ADDENDUM NO. 03 **DATE: 06/22/21**

PROJECT:
Addams Elementary School Building Addition and Modernization
FUSD Bid No 22-01

DARDEN PROJECT NO. 1725
DSA File Nos. 02-117220
DSA APPL. NO. 10-48

1 Partial HVAC Roof Plan - Building L
1/4" = 1'-0"

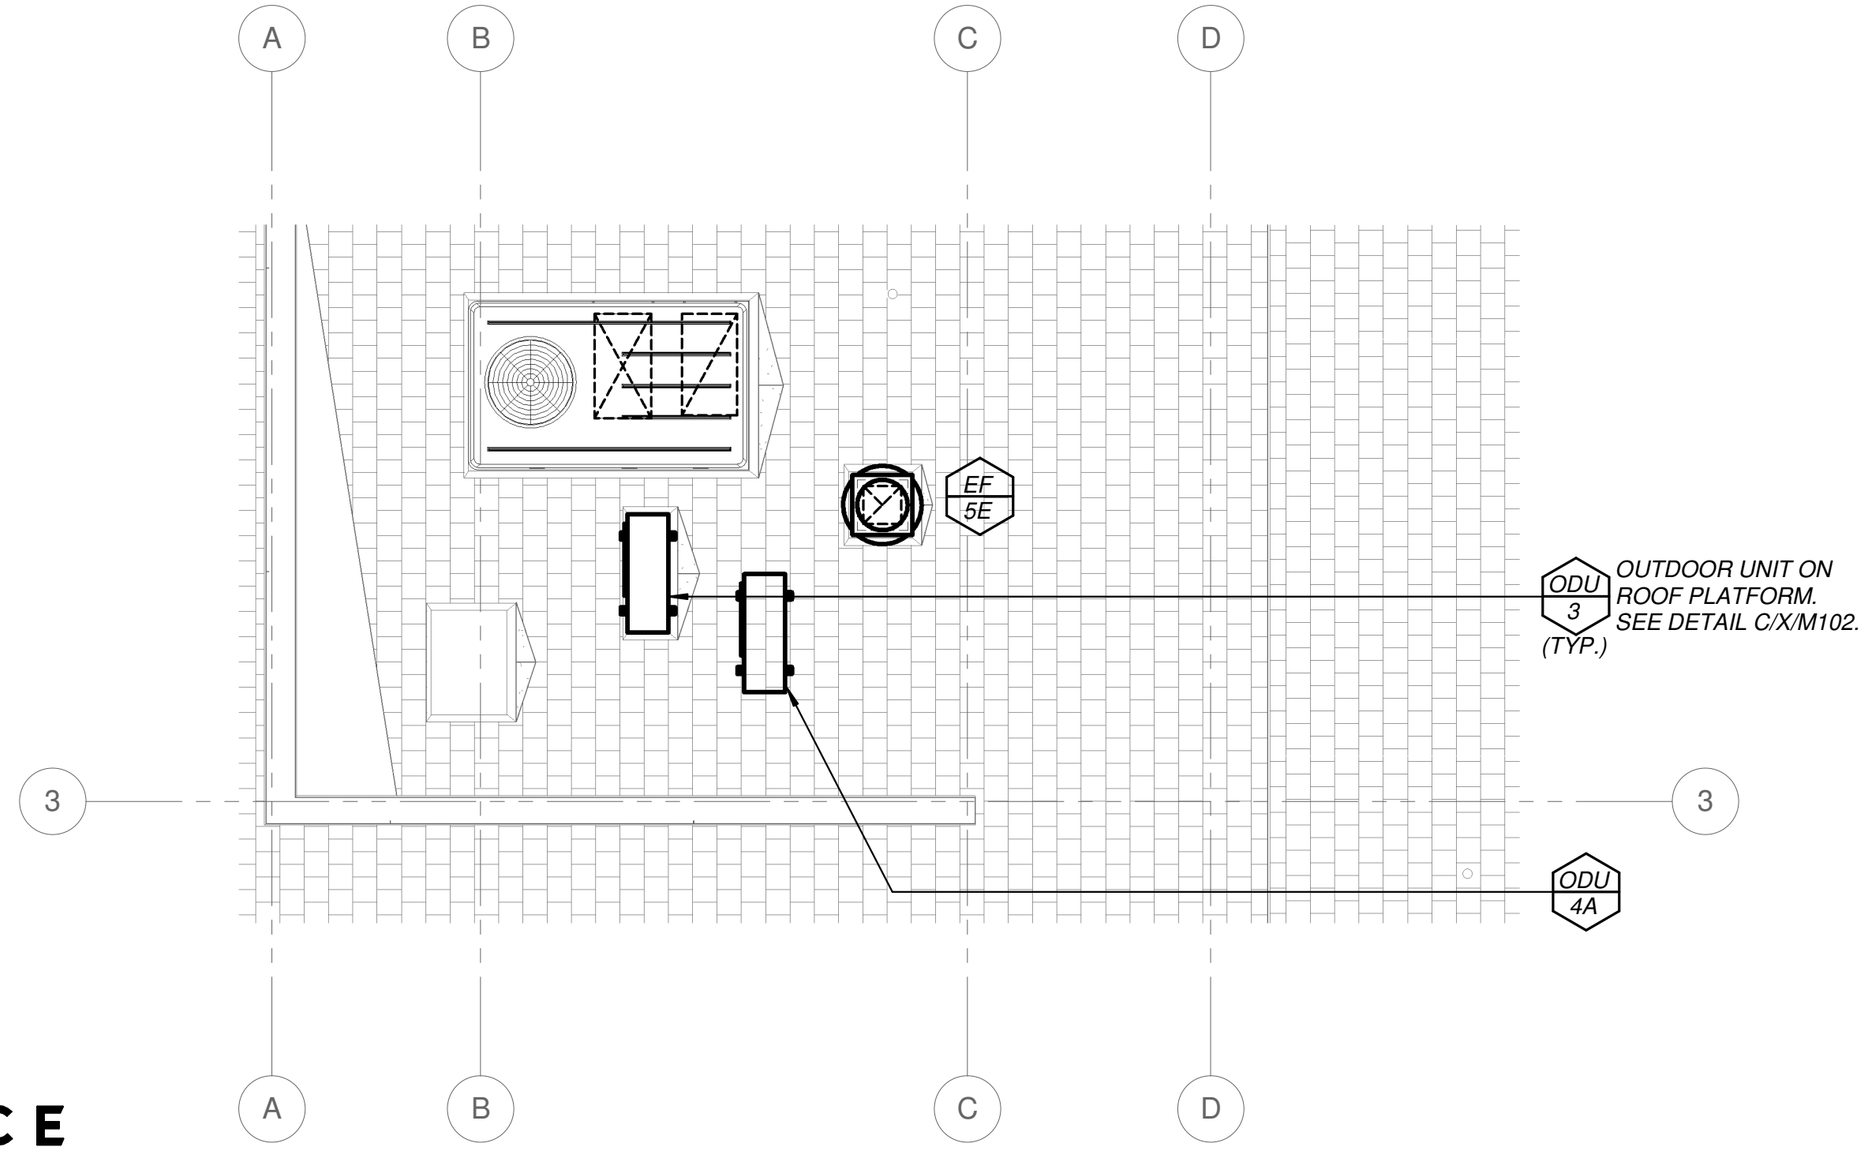
1. Refer to addendum drawing sheet AD3-MX03 for addition of ODU-4A to Electrical Room 115 (new location for main EMS panel).

1 Partial Plumbing Plan - Building L
1/4" = 1'-0"

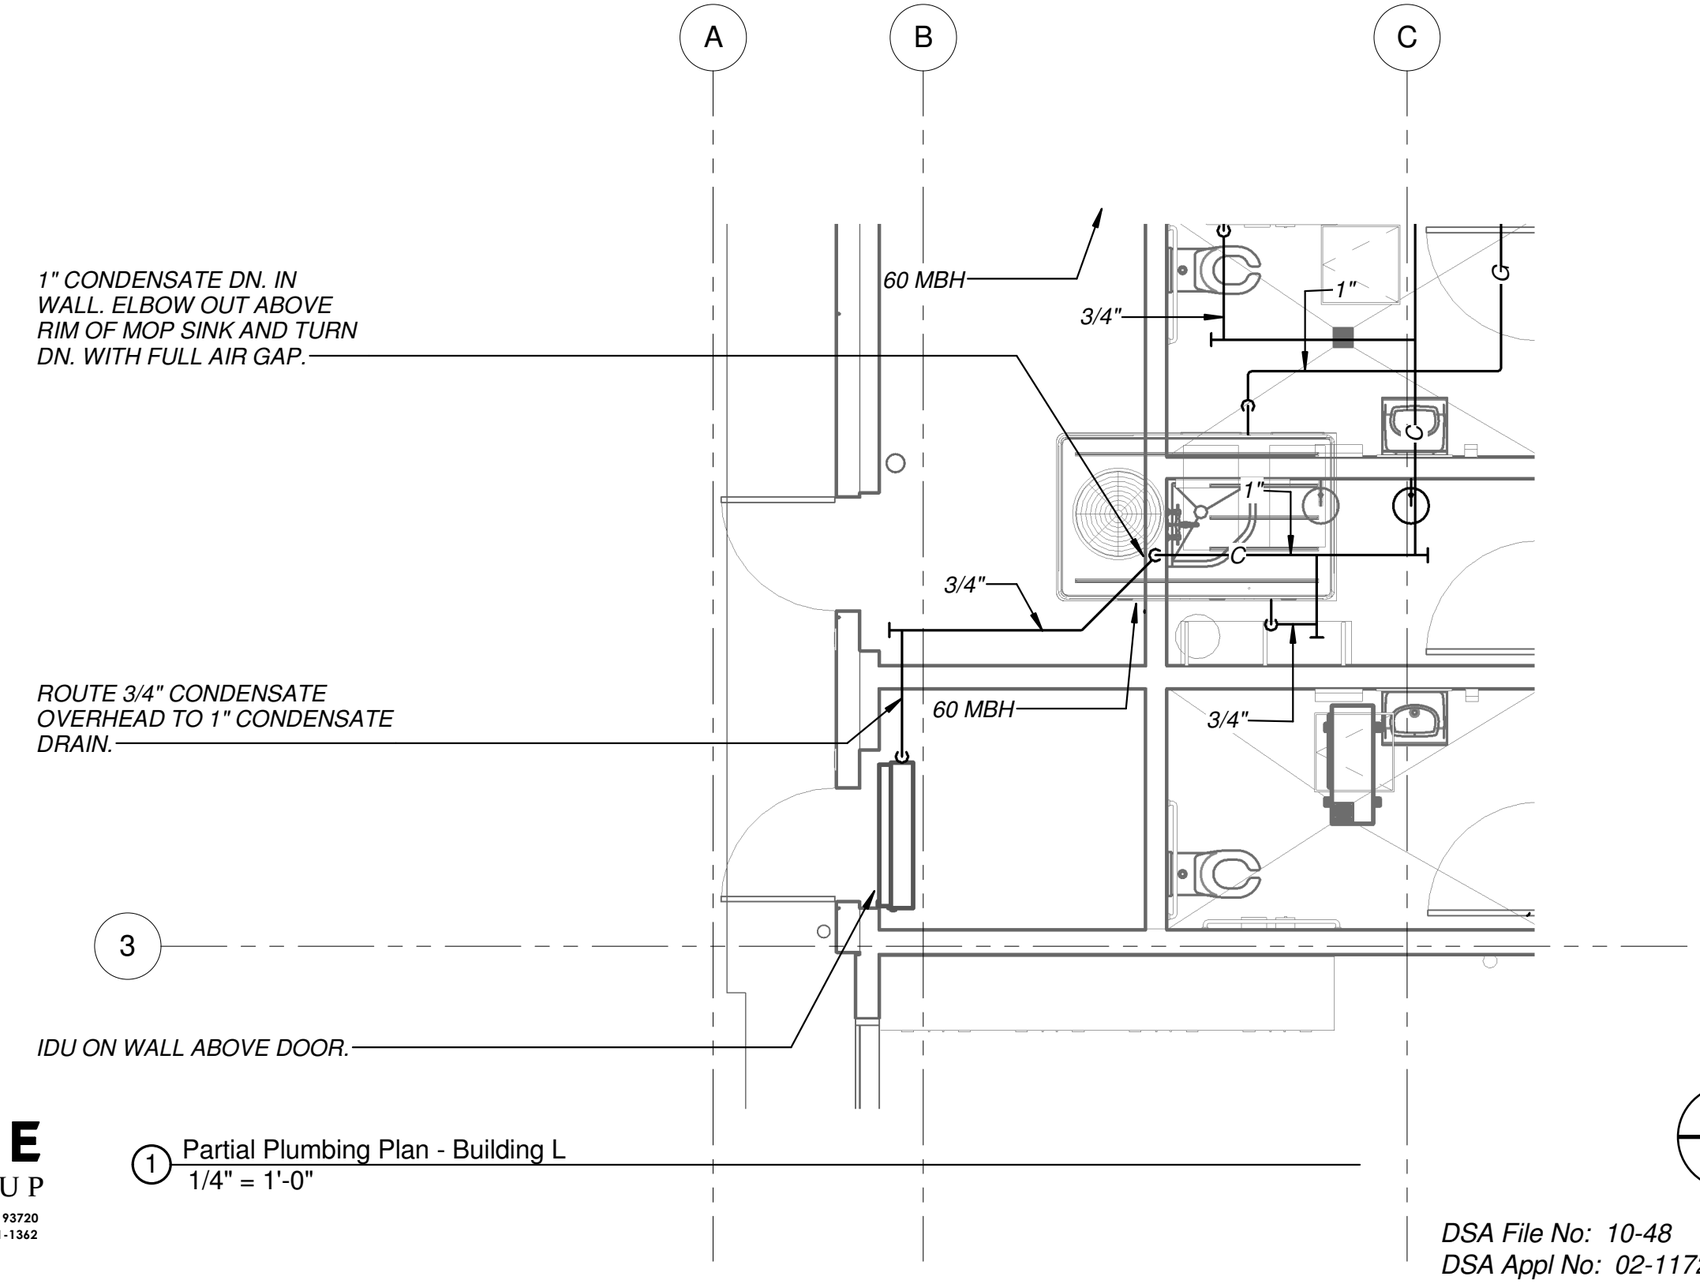
1. Refer to the attached Sheet AD3-PX01, for the partial plan Revisions.
